UNITED STATES PATENT AND TRADEMARK OFFICE

Office Action Summary	Application No. 10/579,365	Applicant(s) KIM, MIN-WON	
	Examiner DAVID C. MELLON	Art Unit 1797

3. **Claim 3 is rejected under 35 U.S.C. 102(b) as being anticipated by Horne (USP 3,319,791).**

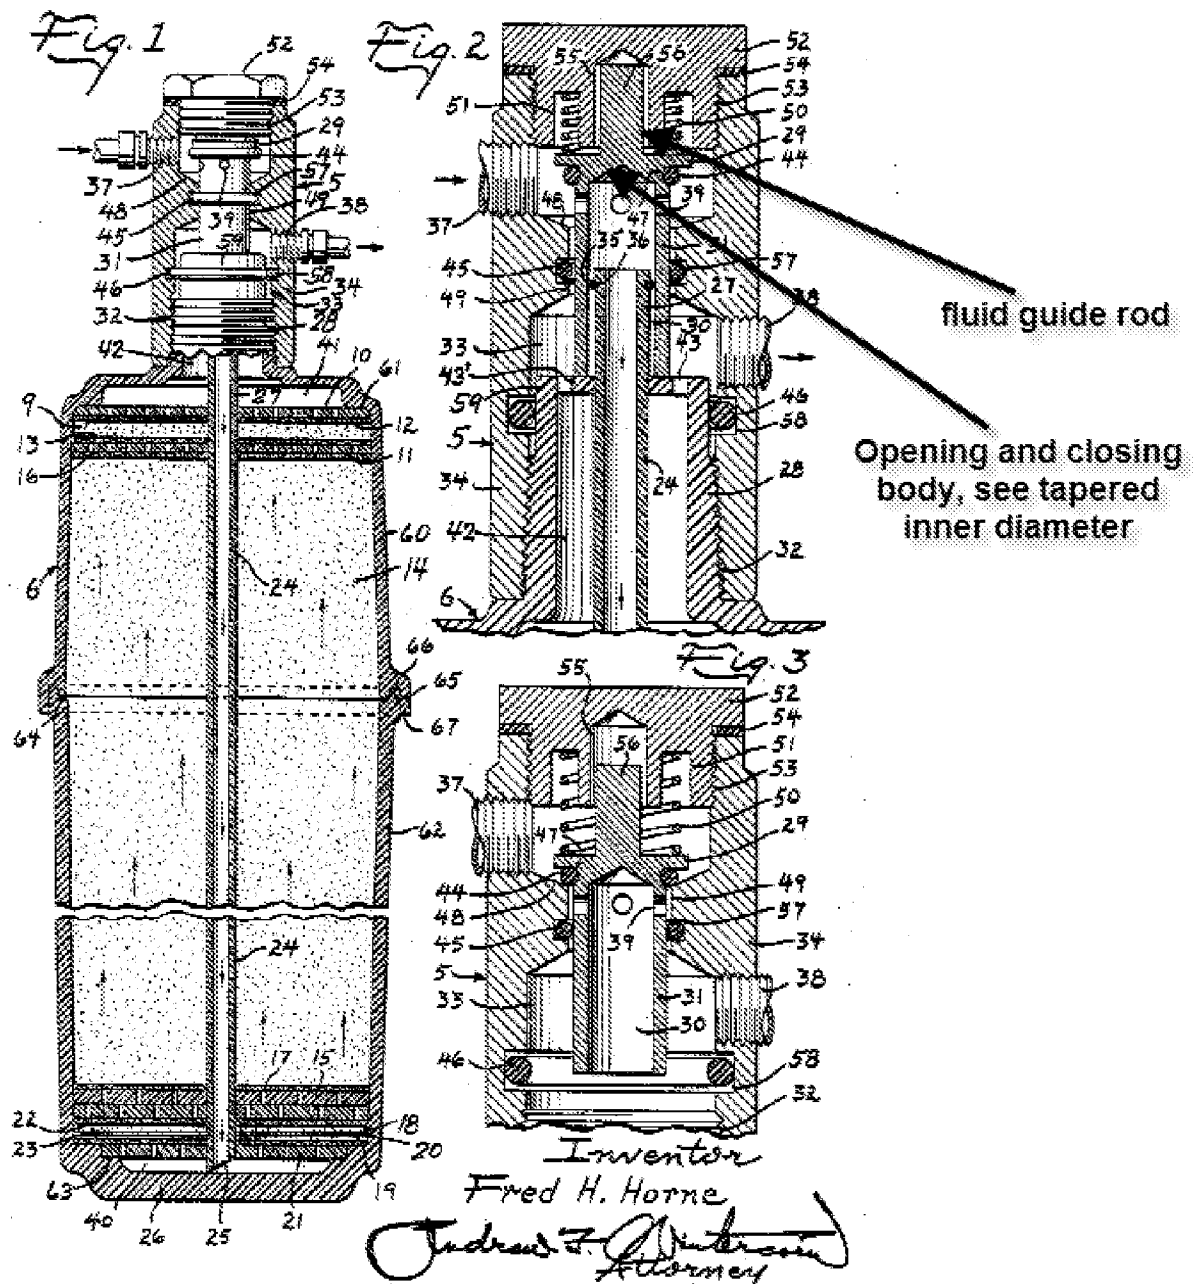
Regarding claim 3, Horne discloses in figures 1-3 (see also annotated figures), a poppet valve and container combination (title) comprising:

a head (5) having a guide passage (passage between inlet 37 and conduit 24, see also internal space around the valve assembly) and an inlet port (37) and an outlet

a filter body (6, see also C1/L60-C2/L25 where clearly the container is intended as a filter by internal components discussed) threadedly locked to said head (threading 28 and 32 connects the components together), said filter body in fluid communication with said guide passage and said inlet port and said outlet port so as to receive fluid from said guide passage and said inlet port and to transfer purified fluid to said outlet port; and

a fluid flow interrupting means disposed in said guide passage (poppet valve component including pilot end 56, also 29, 44 and other parts), said fluid flow interrupting means having:

a fluid guide rod formed at one end thereof (56),

an opening and a closing body connected at one end thereof to said fluid guide rod (see annotated figure 2),

said opening and closing body having a gradually decreasing diameter (see tapered internal diameter part) with an O-ring fitted therearound adjacent one end thereof (o-ring 44) and an opening and closing projection formed adjacent an opposite end thereof (see aspect below o-ring),

an elastic spring cooperative with said guide passage for controllably opening and closing said guide passage by force of said elastic spring when said head and said filter body are coupled and uncoupled from each other (50, C2/L52-70),

said filter body having at least one through hole defined at an upper end thereof so as to allow fluid from said guide passage and said inlet port to flow into said filter body (conduit 24),

said guide passage having a hollow cylindrical protuberance formed at one end thereof (55 - central bore), said hollow cylindrical protuberance having an inner diameter greater than an outer diameter of said fluid guide rod (this is clearly shown in the figure),

said guide passage having a gradually decreasing inner diameter at an opposite end thereof (see decreasing diameter of beveled valve seat 48), said fluid guide rod inserted through one end of said elastic spring (clearly fluid guide rod is through the spring), said elastic spring having another end fitted around said hollow cylindrical protuberance (spring 50 is in groove 51 around 55), said fluid guide rod suitable for guiding fluid therearound (fluid would be guided around rod 56), said elastic spring being supported by said hollow cylindrical protuberance (55 has groove 51 in a portion of it).
